## MEMORANDUM

**Date:** March 04, 2010  
**To:** Water Right File 37-22495  
**From:** jstanton  
**Re:** Comment/Analysis

37-22495 IPCO

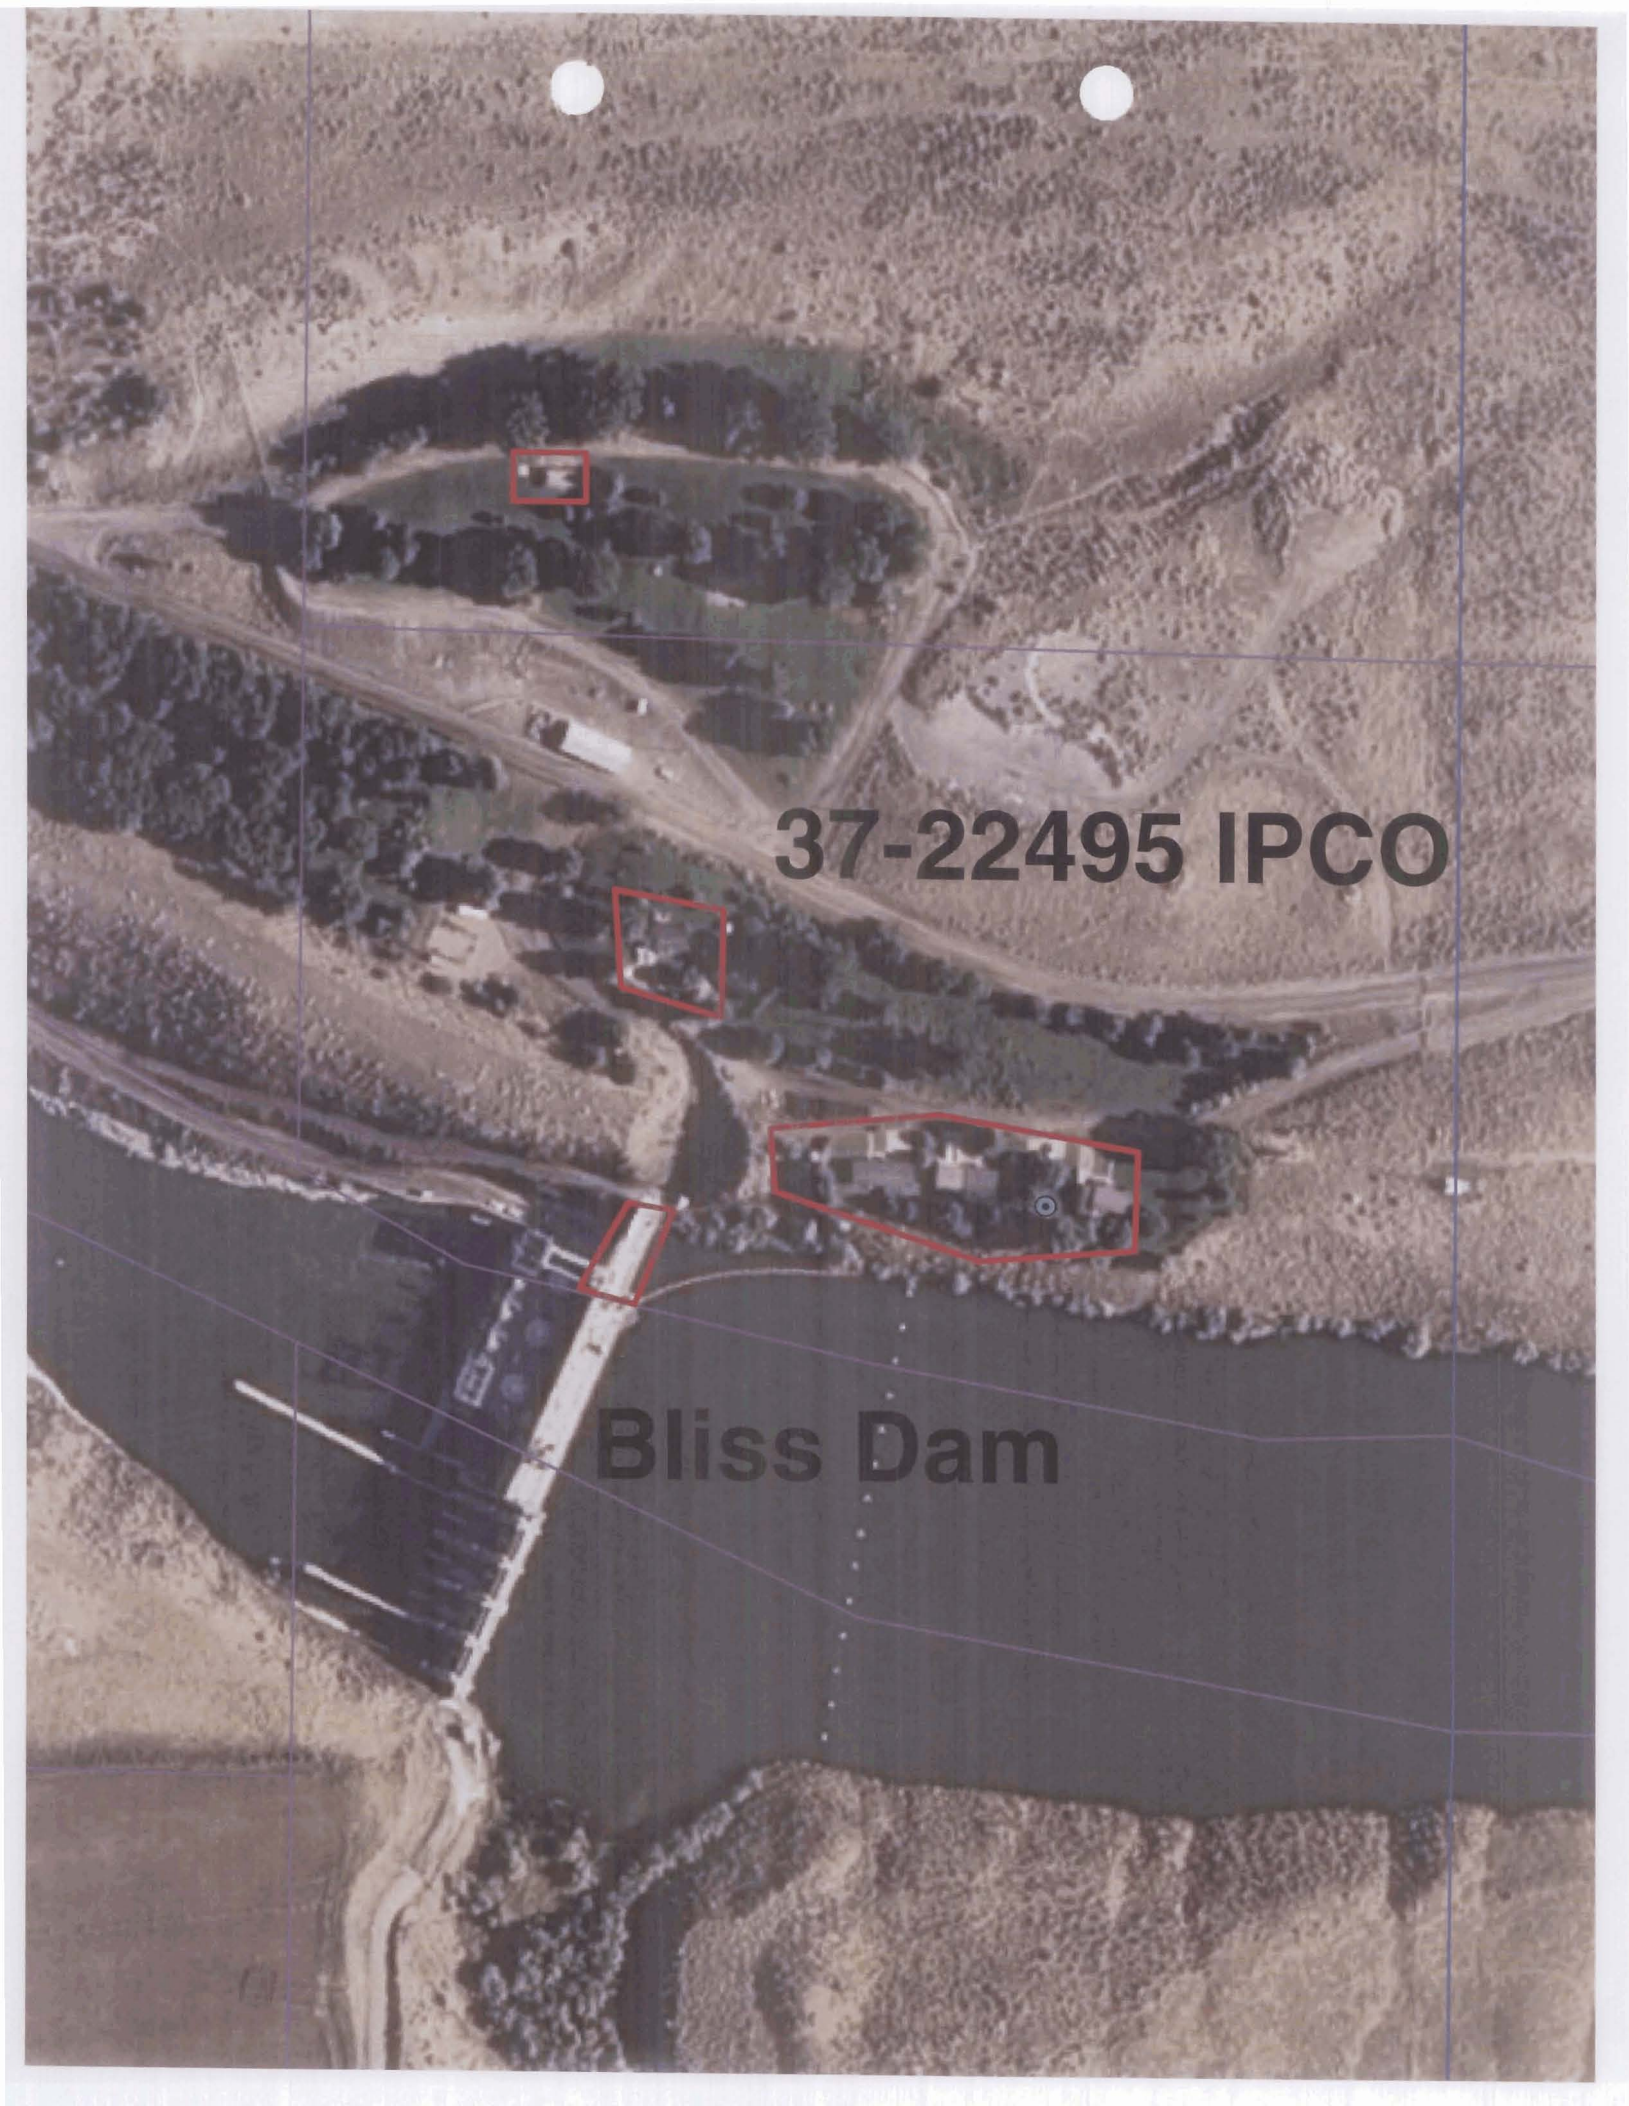
While the application as filed only lists use in Lot 5, it is clear from the 2009 ArcMap photo that the restroom in the park is in the SE/NE Sec. 7. After confirming the locations of the various uses with David Blew, I added this tract to the proposed place of use. It should not be necessary to get a signed corrected application to cover this omission. David confirmed that the application was signed by one of their attorneys, so this should not be an issue.
